H. B. ROBINSON STEAM ELECTRIC PLANT, UNIT NO. 2  
DOCKET NO. 50-261/LICENSE NO. DPR-23

SUPPLEMENT 1 TO REQUEST FOR TECHNICAL  
SPECIFICATIONS CHANGE FOR ULTIMATE HEAT SINK (UHS)

REVISED MARKUP OF CURRENT TECHNICAL SPECIFICATIONS  
AND BASES PAGES

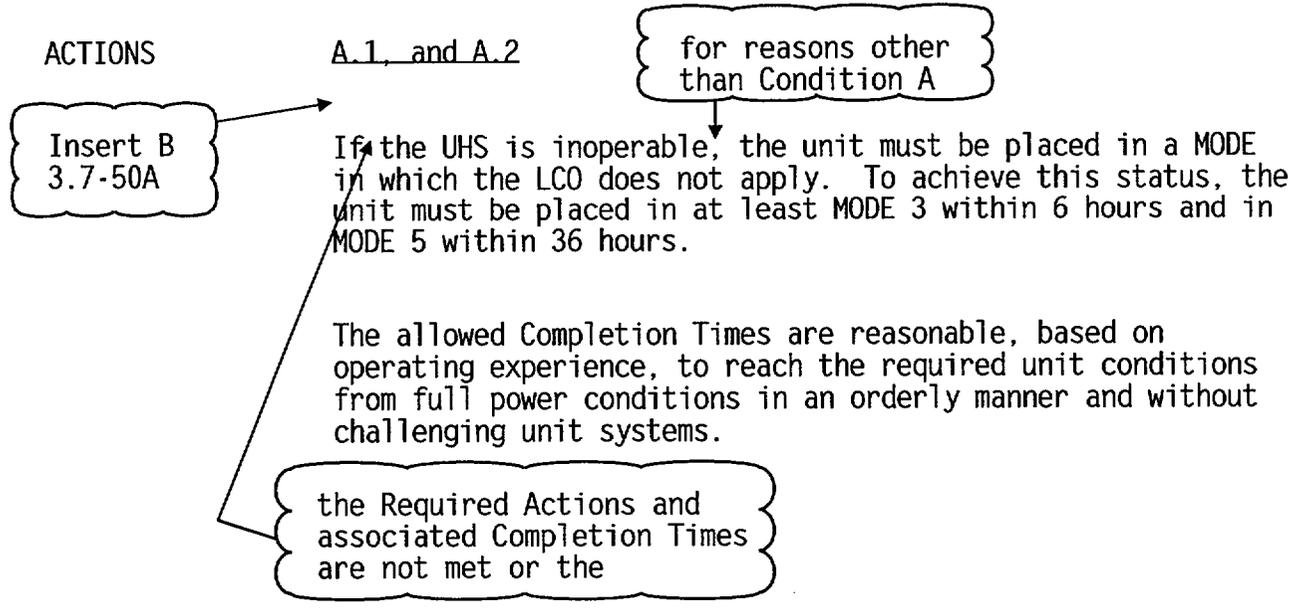
LCO      The UHS is required to be OPERABLE and is considered OPERABLE if it contains a sufficient volume of water at or below the maximum temperature that would allow the SWS to operate for at least 22 days following the design basis LOCA without the loss of NPSH, and without exceeding the maximum design temperature of the equipment served by the SWS. To meet this condition, the UHS temperature should not exceed 97°F and the level should not fall below 218 ft MSL during normal unit operation.

With the SW temperature  $> 97^{\circ}\text{F}$  but  $\leq 99^{\circ}\text{F}$ , the required cooling capacity of the SW System must be verified by evaluating the existing operational condition of the systems and components served by the SW System and verifying that each is capable of performing its safety related function. The required cooling capacity must also be re-verified once per 12 hours. In addition, the SW temperature must be verified  $\leq 99^{\circ}\text{F}$  once per 1 hour. The temperature verification ensures the SW temperature remains below the maximum water temperature allowed for the safety related components to perform their safety function.

The Completion Time of Required Action A.1 was developed considering that some activities required to complete the evaluation of required cooling capacity could be completed prior to the Condition being entered.

The Completion Time of Required Action A.2 is based on shift schedules for convenience and is considered acceptable since temperature monitoring capability is available to detect an increase in SW temperature throughout the period of Condition A.
